PROPOSED CROSS KEYS STREET ELEVATION

APPROVED GOULDEN STREET ELEVATION

PROPOSED GOULDEN STREET ELEVATION

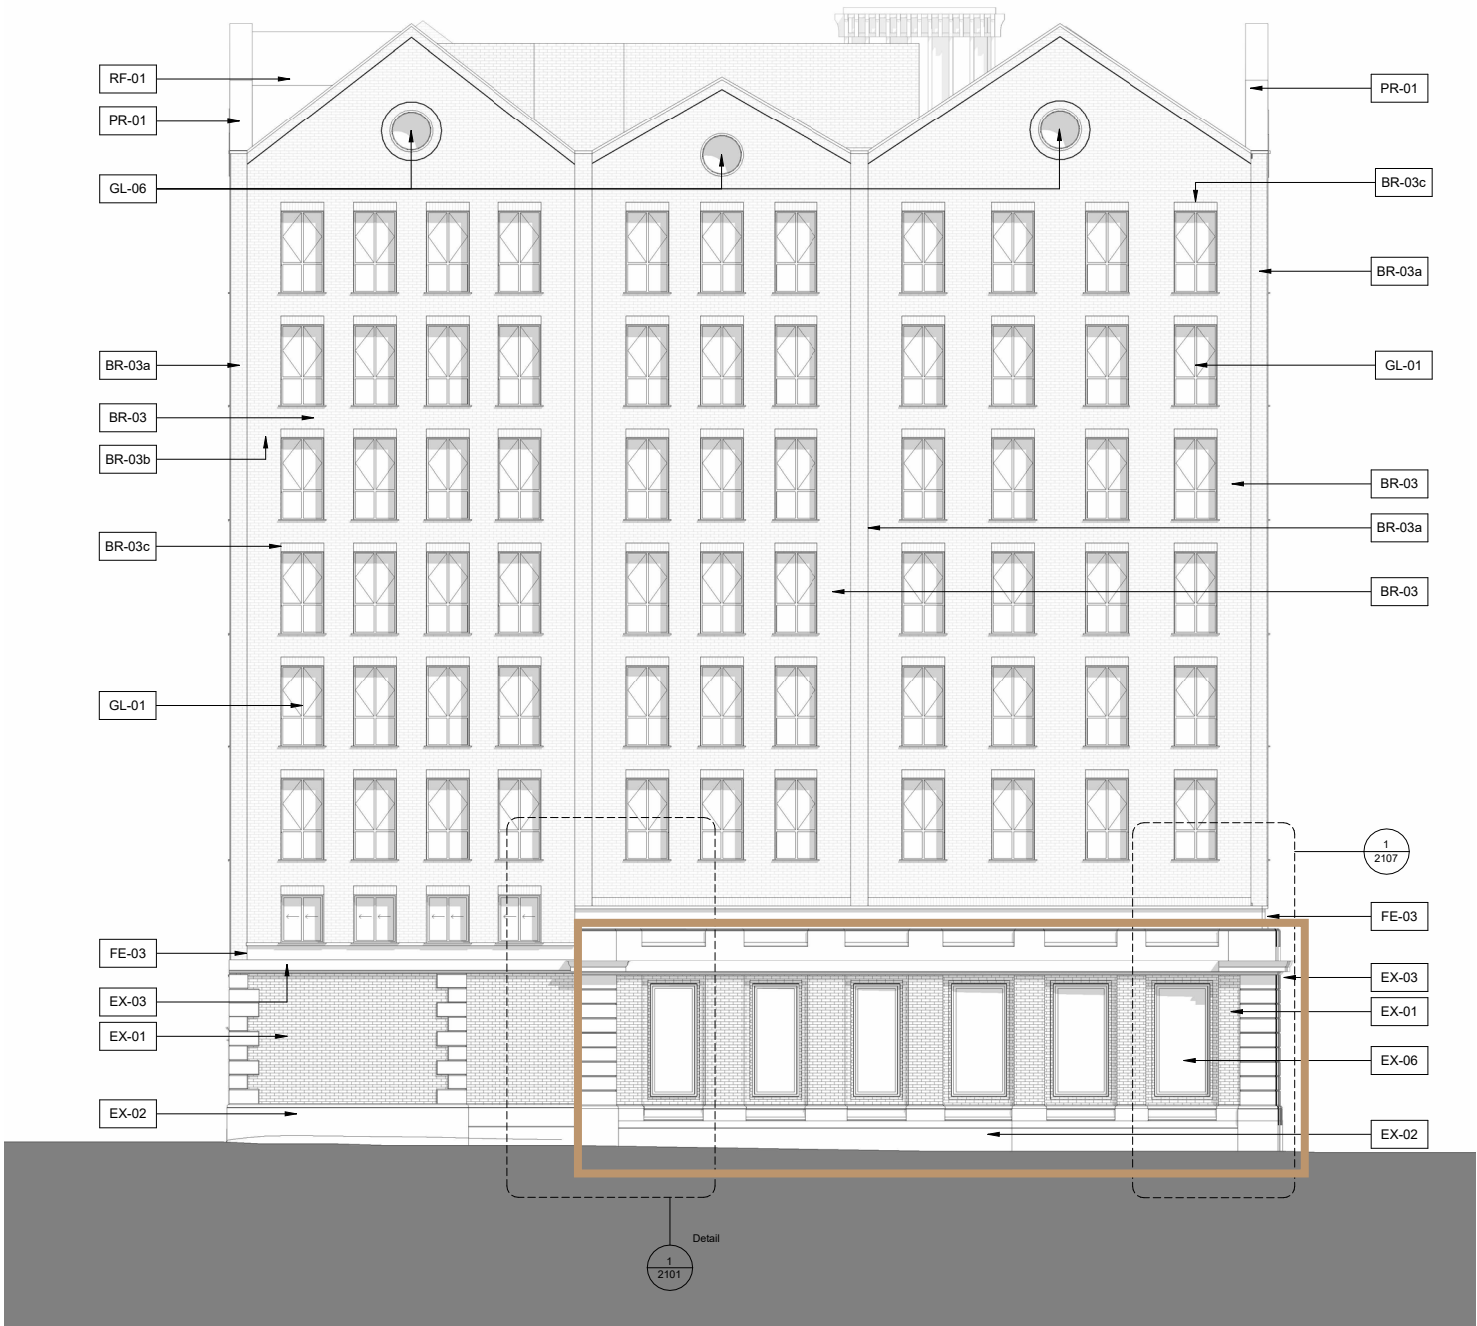
Amendments have been made to the elevation along cross keys street to suit the proposed apartments. The changes also more closely replicates the original facade along cross keys street with the openings being uniform across the facade.

This would require the base of the ashlar wall being in-filled with the base from another part of the wall being demolished. Further reparation work may also be required where previous changes have been made.

Minor changes have been made to the proposed Goulden Street Elevation with the proposed apartments located behind one side of the entrance. The changes made protect the ground floor apartment given the heavy footfall expected at the entrance.

The signage for the building has also been amended to suit the new design of the curtain walling.

We experimented with opening the decorative elements in the ashlar wall similar to on Cross Keys street. However, we felt this compromised the solidity of the entrance and found that these had not historically been open.

Slight change to the ambulance door openings is made along bendix street to suit the new arrangement of services and entrance along the building. The strategy to replicate the existing ambulance doors remains the same with the infill panels being different depending on the purpose.

PROPOSED COURTYARD ELEVATION

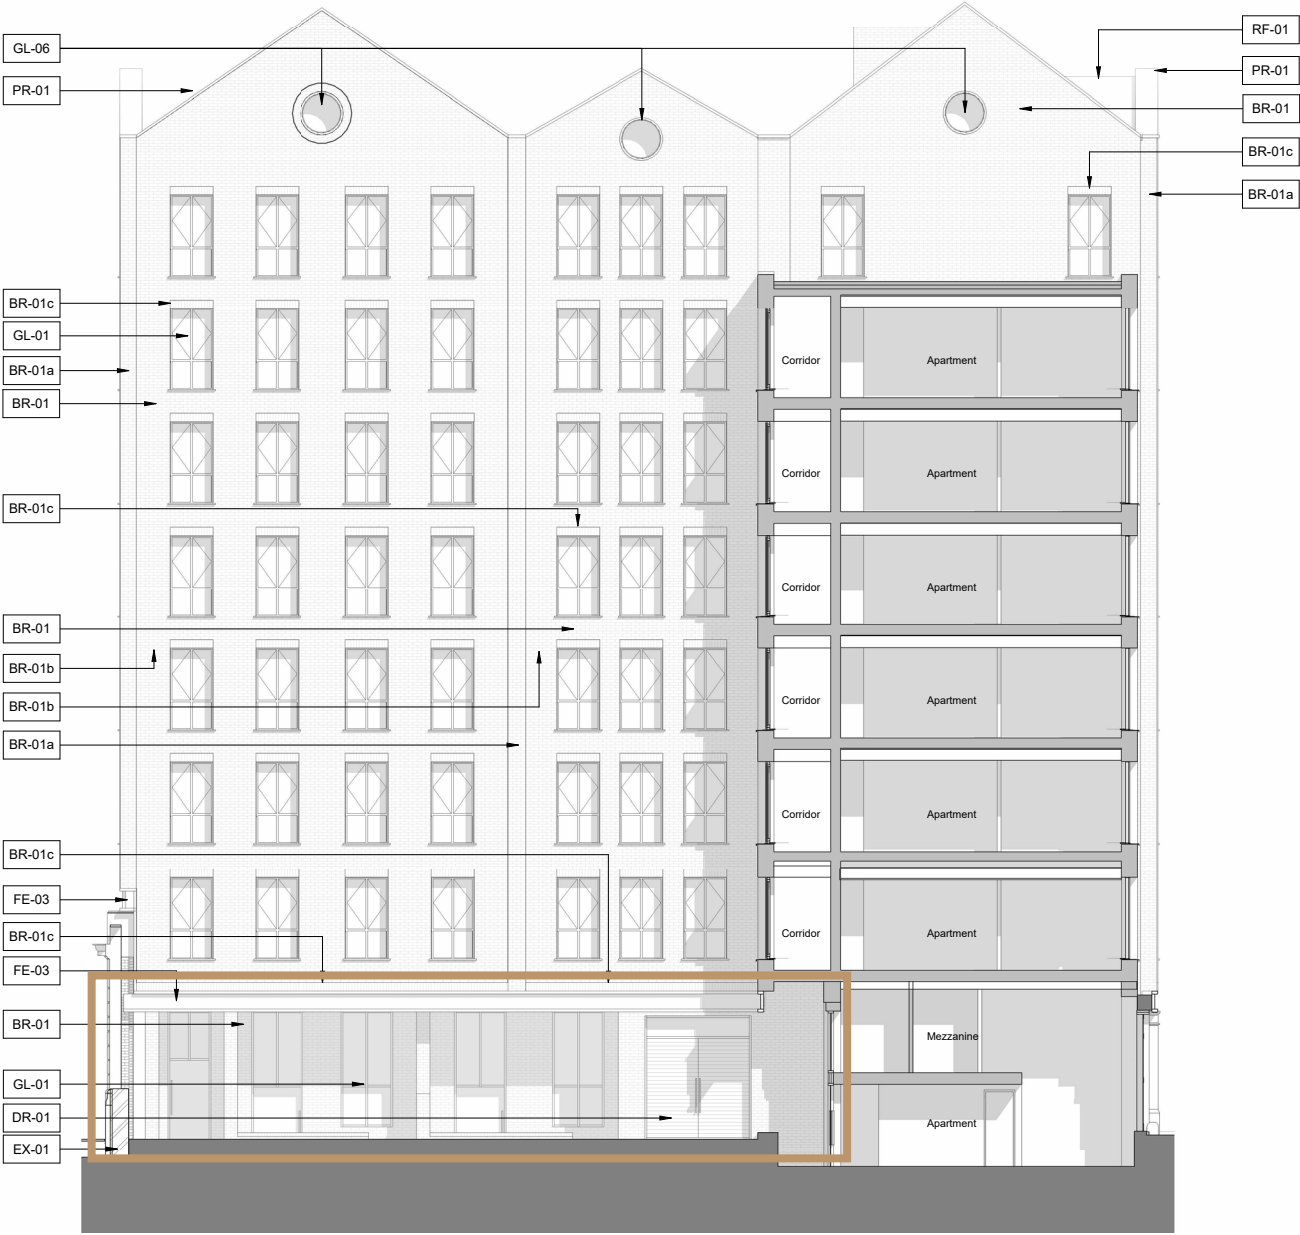
The introduction of apartments at ground level have led to changes in the facade treatment facing into the courtyard. The lower portion of the facade will be set back to allow the sunken access into the apartments and allow greater privacy from the courtyard.

The facade facing onto Goulden street will use a similar window type to the windows above with an openable window panel and metal grill providing ventilation. These align with the openings above to maintain a consistent pattern on the facade.

The courtyard facade facing onto Chadderton street has similar changes made with the addition of the ground floor apartments. The alignment of the openings differ slightly from the openings above but have the same layout of mullions and transoms for the window frame.

PROPOSED COURTYARD ELEVATION

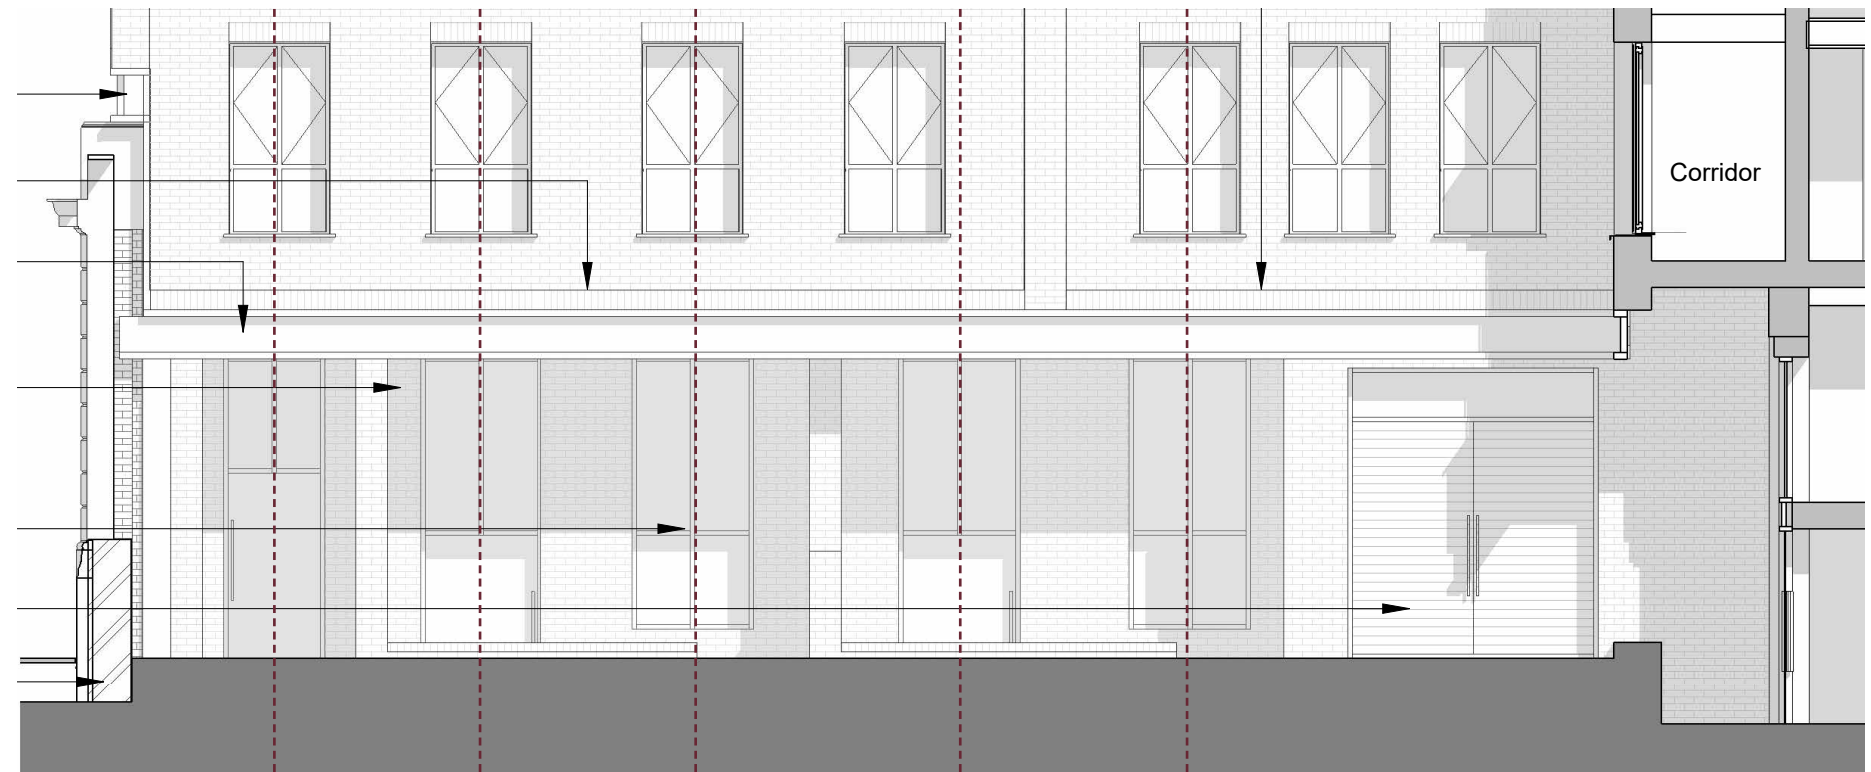
To maintain consistency with the facade above, where possible, we have continued the alignment of openings and thresholds at the ground level apartments.

PROPOSED COURTYARD ELEVATION

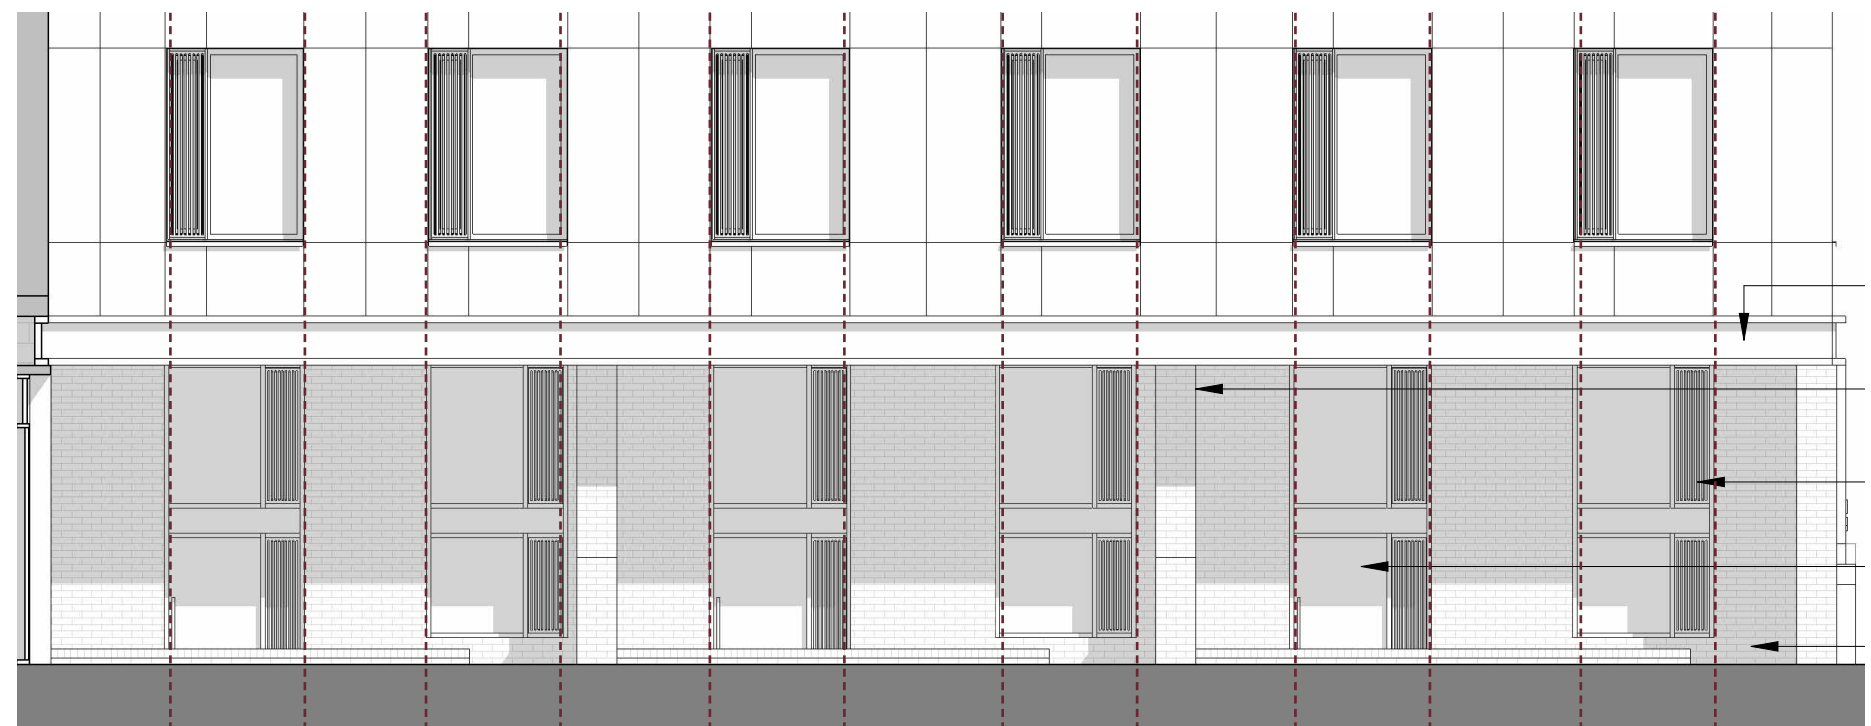
It is proposed that the materials for the ground floor units facing into the courtyard should mimic the colour of the material above. For the elevation facing Chadderton Street, this sees the White/Grey brick being carried down to floor level - matching the above.

The elevation facing Goulden Street is made from a black brick, matching the black metal panels above. All window openings and black spandrel panels will be of the same colour and material as elsewhere in the project.
